INDIANA DEPARTMENT OF TRANSPORTATION

STANDARDS COMMITTEE MEETING

REVISED AGENDA

January 15, 2009 Standards Committee Meeting

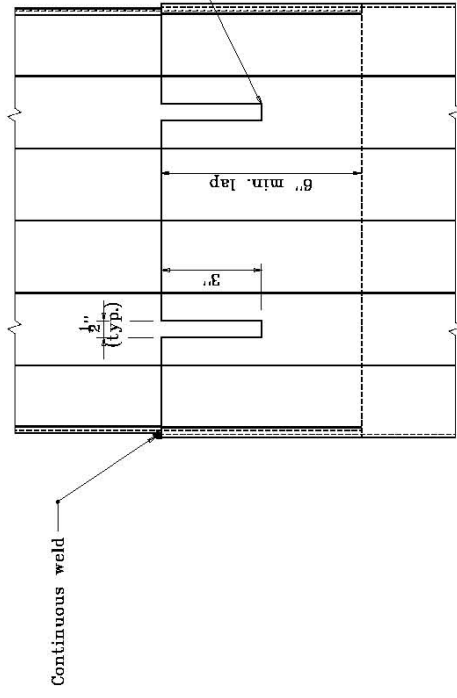
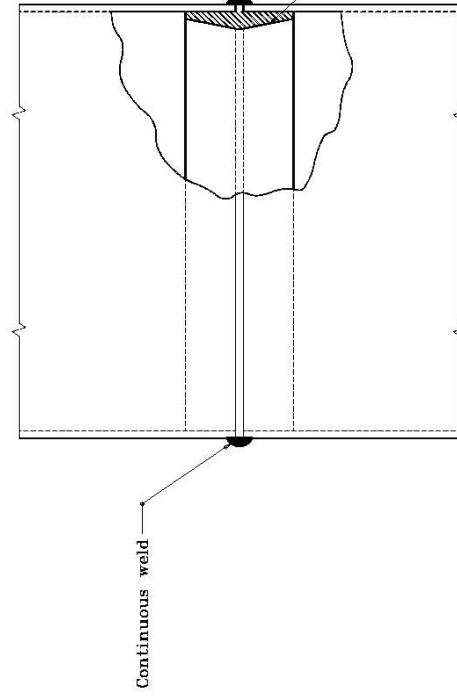
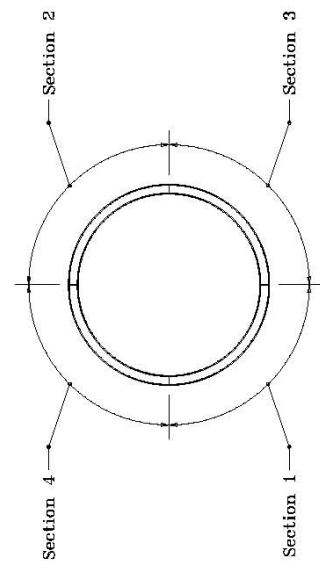
FOR FLUTED ~~SHELLS~~ PIPE

FOR ROUNDED PIPE

506-CCPP-01 CONCRETE PAVEMENT PATCH DETAILS

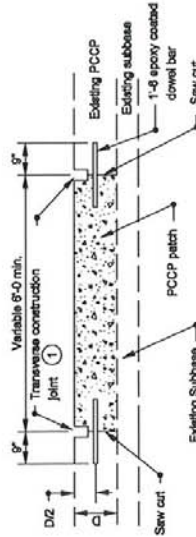
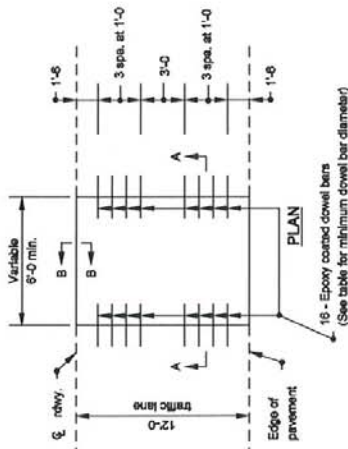
REVISION TO STANDARD DRAWING AND 2008 STANDARD SPECIFICATIONS

MOMENT SLAB ASIDE MSE WALL - PCCP

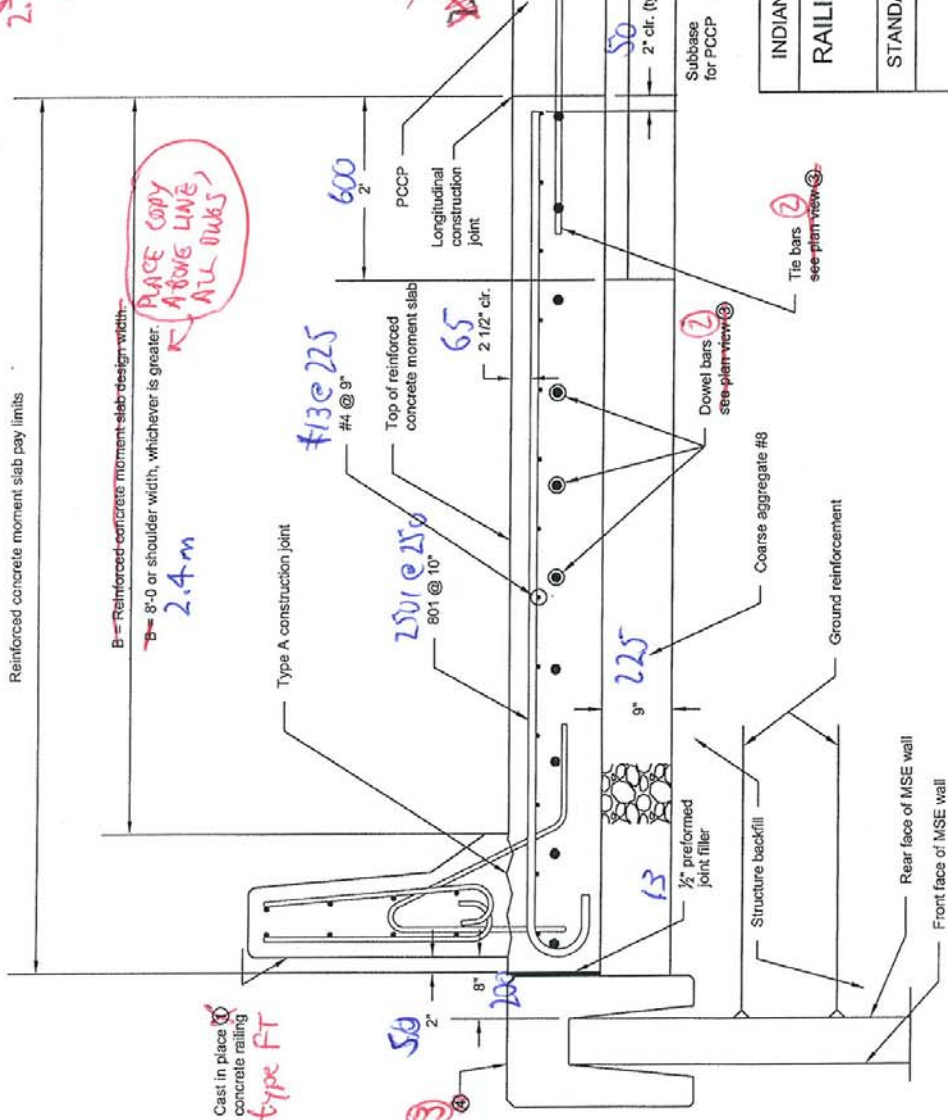
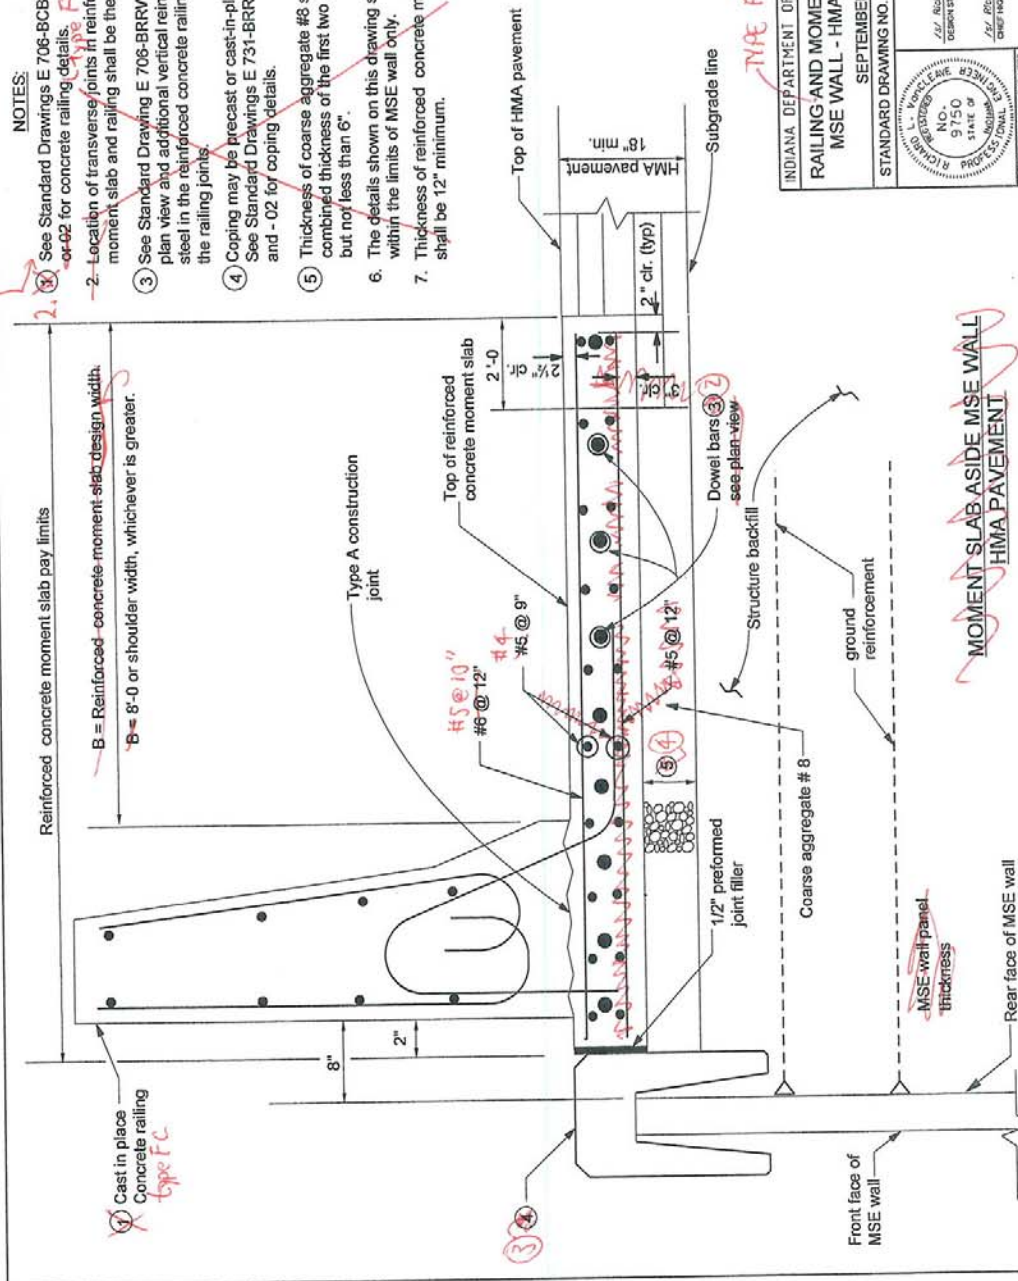
Existing standard drawings 706-BCBR-01, -02, and -04 for concrete bridge railings are being revised to identify the common- and truck-height railings by a type designation.

NEW DWG.

**BRIDGE RAILING
TYPE FC**

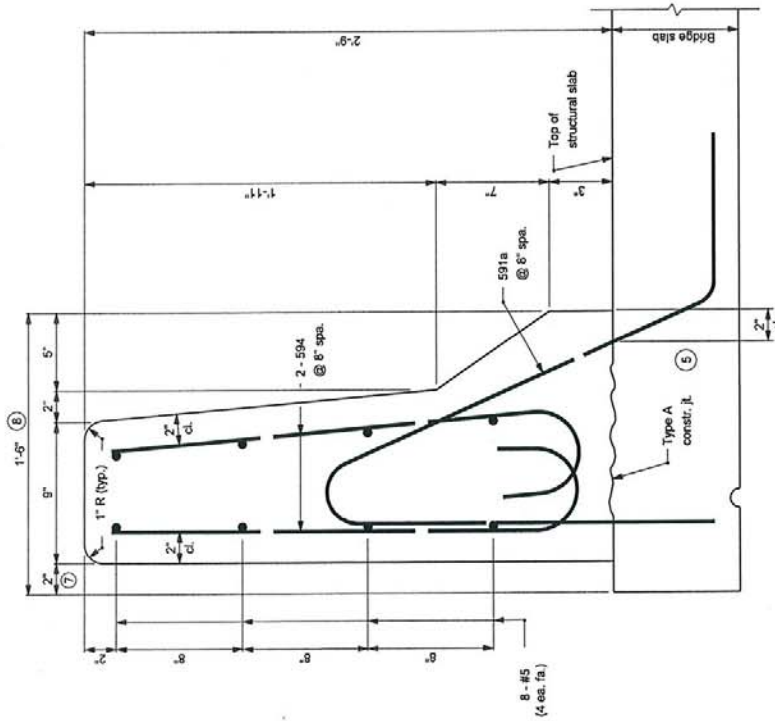
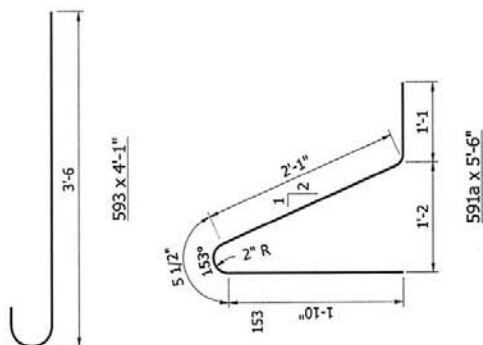
~~TRUCK 45" HEIGHT~~
~~CONCRETE BRIDGE RAILING~~
